Access Compliance Report Public Rights-of-Way (Curb Ramps)

Main Street: SPRING_ST		Cross Street: S_ESPLANADE_ST		Location:	NE
ADA ID: RPAT210927112835	Ramp Type:Type 1 - Perpendicular	Initial Pass/Fail: Fail	Overall Compliance: No	Severity Score:	15

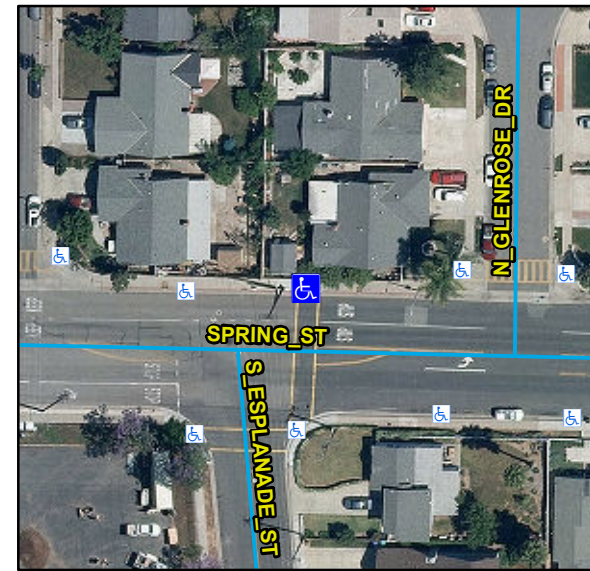
R304.2.2, STD 1115

Remove & Replace Entire Ramp.
